MANCHESTER TOWNSHIP PLANNING COMMISSION AGENDA

RE: 3875-3885 Board Road – Office & Storage
Preliminary/Final Subdivision & Land Development Plan
Manchester Township Plan #2025-07
Engineer's Project No. 0841.3.02.A1
Response #1

Re: 3875-3885 Board Road – Office & Storage
Preliminary/Final Subdivision & Land Development Plan
Manchester Township Plan #2025-07
Engineer's Project No. 0841.3.02.A1

STORMWATER EASEMENT

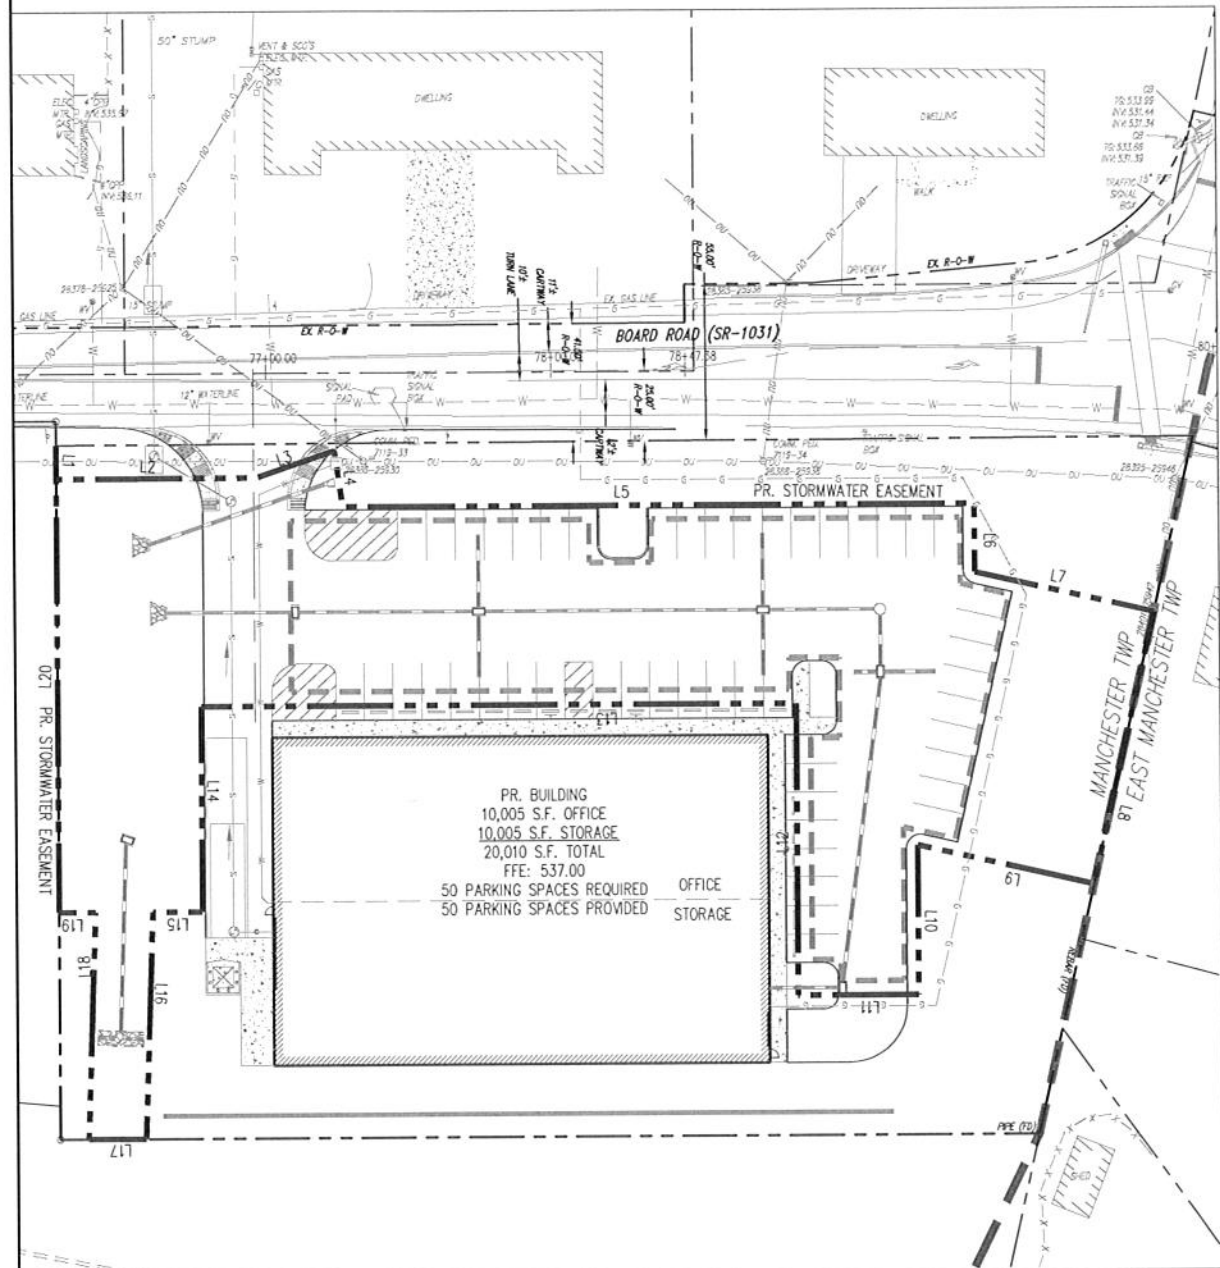
6. On sheet 7, expand the proposed stormwater easement (L18 and L24) to the eastern property line to allow for inspection/repair of any future erosion/scour.
The stormwater easement is revised to extend to the property line.

5. A plan and construction details for the proposed retaining shall be provided and sealed by a structural engineer.
6. On sheet 7, expand the proposed stormwater easement (L18 and L24) to the eastern property line to allow for inspection/repair of any future erosion/scour.

SANITARY EASEMENT

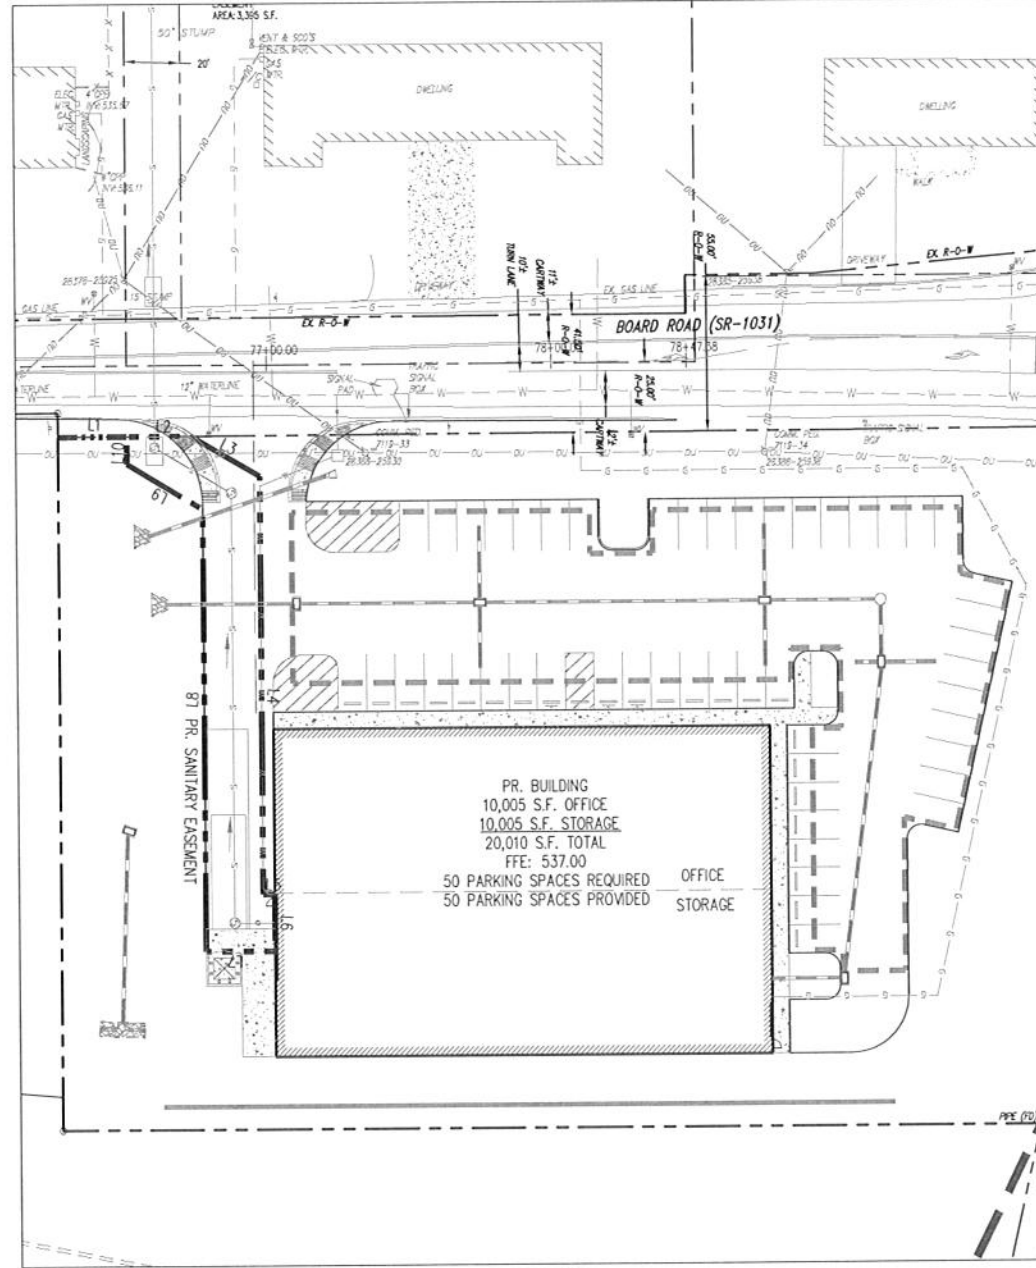
8. The proposed sanitary sewer easement required to be provided shall be described on the plans with bearings and distances.
The easements are added to the plan. They are illustrated on sheet 9 of 17.

8. The proposed sanitary sewer easement required to be provided shall be described on the plans with bearings and distances.
9. A table shall be provided for the UPI to be assigned to the consolidated lot.

STOP SIGN DETAIL

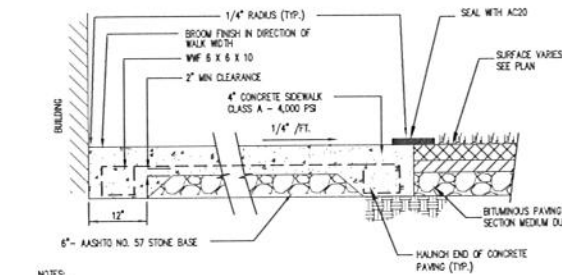
1. Add the following note to the cover sheet: "All traffic signs are to be installed per the PennDOT standard for the installation of Type B Post-Mounted Signs. Refer to Section 931 in the current version of PennDOT Publication 408, Specifications."
2. The proposed STOP sign on the access drive at the intersection with Board Road shall be 30"x30".

The detail for the proposed Stop Sign is revised to be 30" X 30".

STREET CROSS SECTION - CURB & SIDEWALK

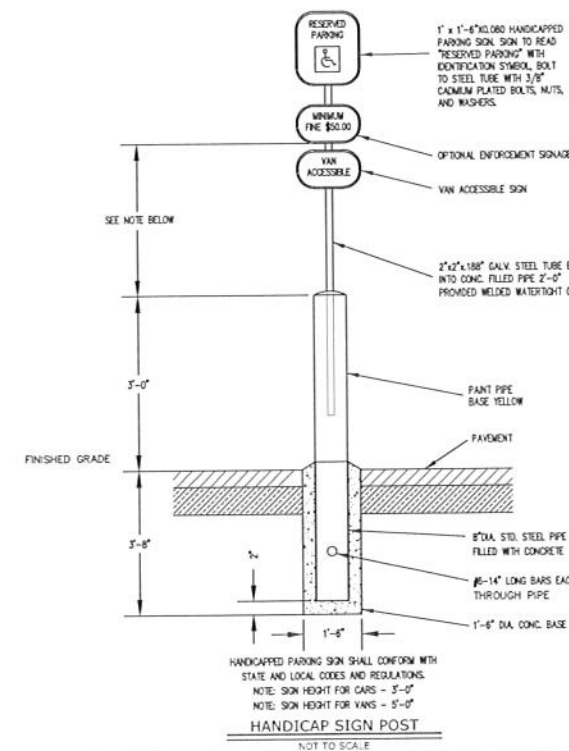
24. Zoning boundaries shall be identified and labeled.
The Zoning boundary is identified and labeled on the plan.
25. A street cross section shall be provided showing the proposed future location of curb and sidewalk.
The street cross section is added to the detail plan sheet 15 of 18.
